## **STAFF REPORT AND RECOMMENDATION TO THE DESIGN COMMISSION**

CASE FILE: LU 18-210124 DZM AD  
PC # 18-159281  
**Block 216**  
REVIEW BY: Design Commission  
WHEN: December 13, 2018 @ 1:30pm  
WHERE: 1900 SW Fourth Ave., Room 2500 B  
Portland, OR 97201

Diagram 1: North elevation (left); East elevation (right).

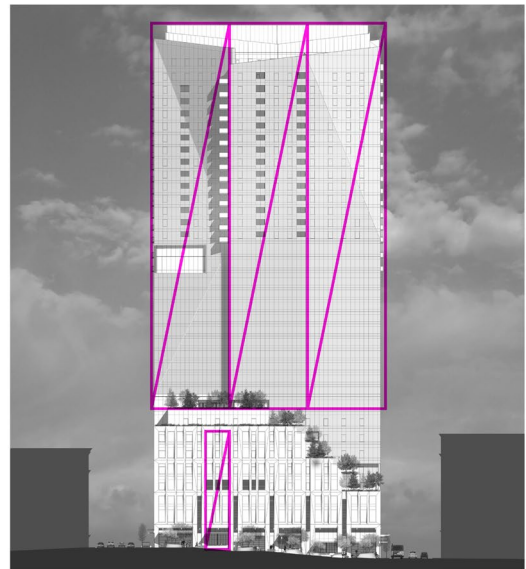
- One massing move that was discussed at some length at the November 1, 2018 hearing was the difference in how the tower related to the podium at both the north and south elevations. At the north elevation, the podium steps back along its western edge, creating a plaza space and allowing the tower to extend down and touch the ground. This expression continues on the north elevation, with the tower extending down to ground. Commissioners found that the extension of the tower to grade elongated the proportion of the tower in a way made the tower more elegant. This elongated proportion also better relates to the proportion within individual bays on the podium and also better relates to the “vertical fold” divisions on the tower. See Diagrams 1 and 2 below.

- Unfortunately, there are no larger-scale elevations or details provided which flesh this option out in more detail. Detailing of this section of the building can be resolved through a follow-up design review, as a condition of approval, to ensure there is a satisfactory response to context and the pedestrian realm and to ensure that overall coherency is maintained and strengthened. Finally, as one commissioner noted at the November 1, 2018 hearing, this move better accomplishes the crystalline design parti for the building, which is diagrammed on Sheet C.169.

Diagram 2: South elevation (left); West elevation (right).

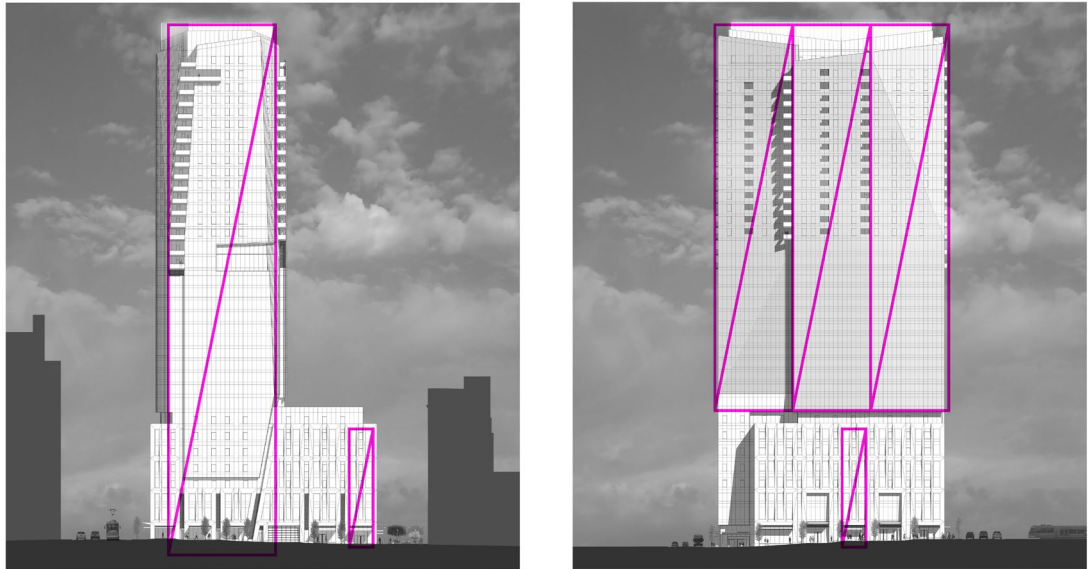
- A design option was shown at the November 1, 2018 hearing that also extended the tower to grade on the south elevation. Many commissioners found this design response to increase the overall coherency between the tower and the podium. Additionally, that design option simplified the terracing on the eastern half of the site, which commissioners also found to improve both overall coherency and contextual response. That same design option is shown as “Option B” on Exhibits C.152 and C.153, and this option’s south elevation showing the tower protrusion should replace the proposed south elevation, which extends the podium’s lower three floors across the south facade.
